Perth Children's Hospital audit – fire walls

BUILDING COMMISSION SUPPLEMENTARY REPORT

PERTH CHILDREN'S HOSPITAL AUDIT FIRE WALLS

An audit of contractor and product
performance in the construction of fire walls
at the new Perth Children's Hospital

Photograph 7: Examples of wall fixings, anchors and attachments

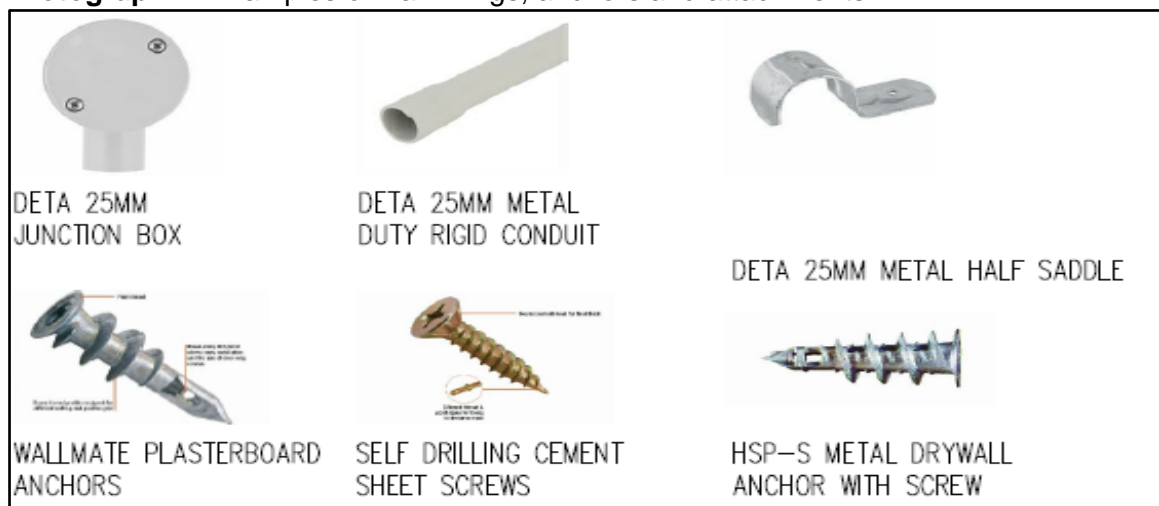
“Non-Fire Rated Components used: Non-fire Rated fixings have been used in Fire Rated Walls, these include Wall Toggles and Wall Mates. These fixings are hollow Fasteners which provide an opening for fire to ingress. No testing exists for any of these components to be installed in the Passivefire wall.”

“Non-fire rated fixings have been used in fire rated walls (including the use of wall toggles and wall mates). These fixings are hollow fasteners and provide an opening for fire to ingress.”

The fire rated walls with these additions may not achieve the fire resistance levels that would otherwise be achieved based on the manufacturer's tested system results.

The Building Commission found that manufacturer's installation system requirements for plasterboard fire rated wall systems to not contain detail or advice on the use of wall fixings other than those needed to fix the fire rated plasterboard.

The Building Commission engaged RED fire engineers to review the use of fixings in fire rated walls and to provide written advice. This advice and the CSIRO testing observed by RED and addressed in Claim 11 satisfies the Building Commission that these fittings and fixings do not adversely affect the fire rating of the wall.

Figure 1: Section showing separation of external window openings in a curtain wall

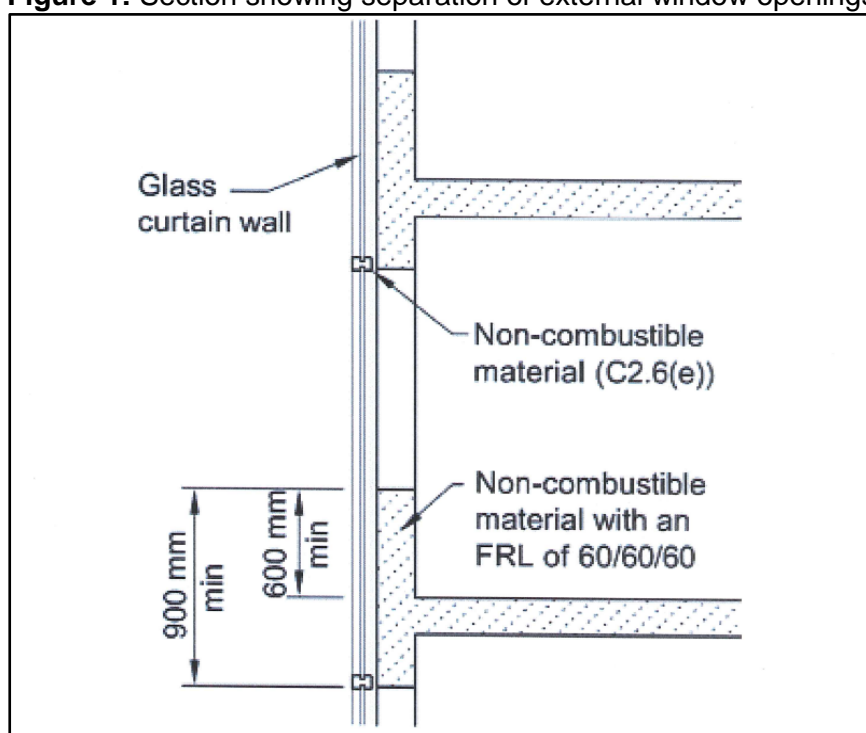
If the external wall of the building is a curtain wall, NCC Provision Part C2.6(a)(iii) contains specific provisions to stop or limit the spread of fire and smoke between the glass and the edge of the concrete floor.

This fire protective measure is important to inhibit the spread of fire and smoke between floors in a Class 9a building (Hospitals).

The Building Commission is satisfied with the review of documents, results of inspection and explanations provided by Strategic Projects and John Holland.

Figure 2: Typical extract of building plans showing non-combustible material (assessed to be for smoke control)

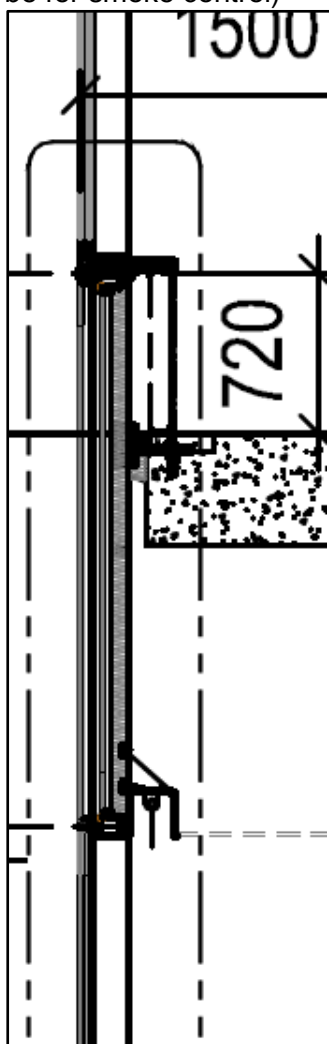
- NCC Volume One, Section C – Fire Resistance, Part C2 Compartmentation and Separation. Clause C2.6(a)(ii)(iii) Non-sprinklered and C2.6(b)(iii) Sprinklered.
- National Construction Code Volume One, Section C Specification C2.5 Smoke proof walls in health care buildings.

As there are sprinkler systems in place NCC C2.6(b)(iii) provides that there is no requirement to fill the gap with fire protective material, however, smoke separation is still necessary. Project approved plans reviewed by the Building Commission with extract shown in figure 2 demonstrate this gap is intended to be stopped up. (Assessed by the Building Commission to be for smoke control.)

Photograph 11: Example of the use of intumescent paint on steel beam connection plate

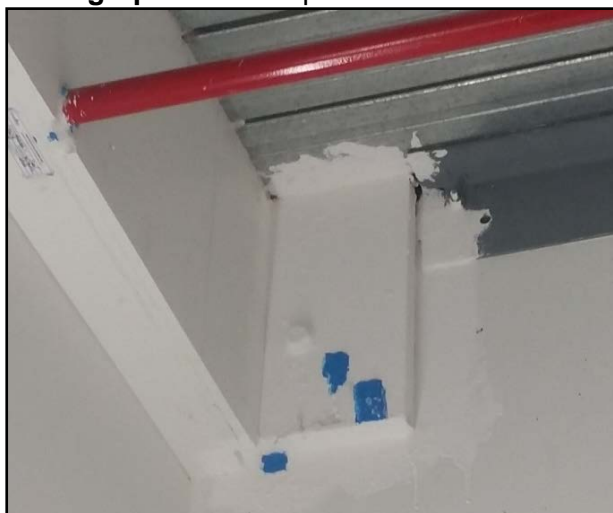
Intumescent paints are used in the construction industry to provide fire resistance to certain structural steel components and if found to be missing or inadequate may cause component failure. It provides an additional level of fire protection to the structural steel beams and the connections to the concrete shaft wall system of the service riser.

The Building Commission determined the relevant parts of the BCA Volume One 2011 for this circumstance to be NCC Volume One, Section C – Fire Resistance, Specification C1.1 – Fire Resisting Construction – 3. Type a Fire Resisting Construction. The Building Commission reviewed the plans and specifications to NCC provisions and determined that some beams did not require fire protection but some did.

Structural steel beams connection points requiring intumescent paint have been rectified by John Holland and no further action is required.

Figure 3: Promat rectification detail for steel beam encasement

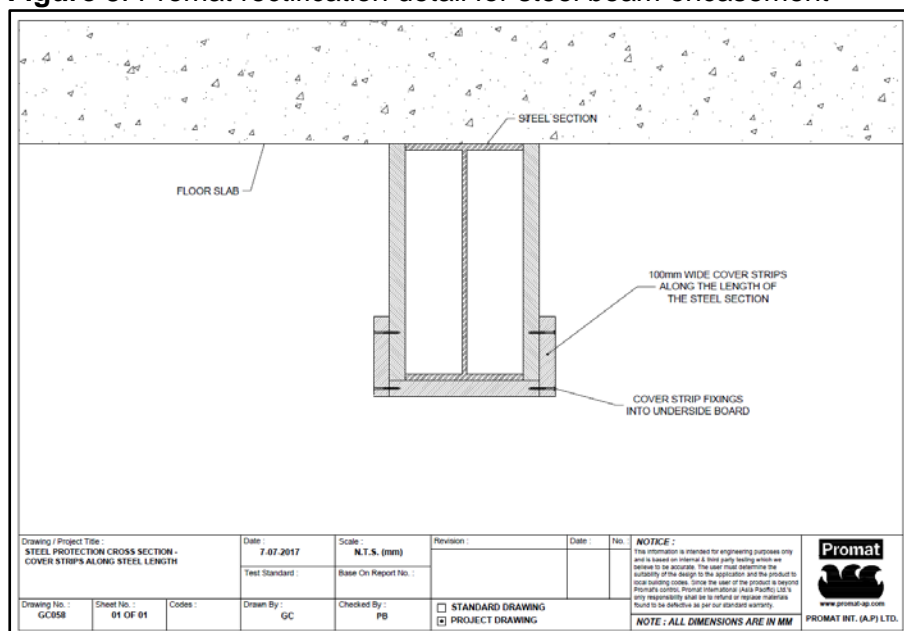
The Building Commission determined the bulkheads to have incorrectly staggered sheeting joints. The manufacturers of the Promat and Knauf fire rated walls both provide specific manufacturer details for protecting bulkheads. The works observed were not installed as per these manufacturer's details. The bulk heads observed were found to be mainly sheeted with Promat product but some were also Knauf product. Both products were approved for use in the project drawings.

They do not meet the DTS requirements for fire resistance without rectification works.

“Originally thought to be layered plasterboard in fact was Promat board, the supplier has said that the directional corner laps are incorrect where the bottom board should be installed between the two side boards. The board supplier is investigating if the system has been tested this way and if not will assist JHG to come up with a solution that can be implemented over the coming weeks. All beams are accessible. This item will be recorded in BIM and closed out following due process. Please see attached manufacturer resolution, works are currently underway.”
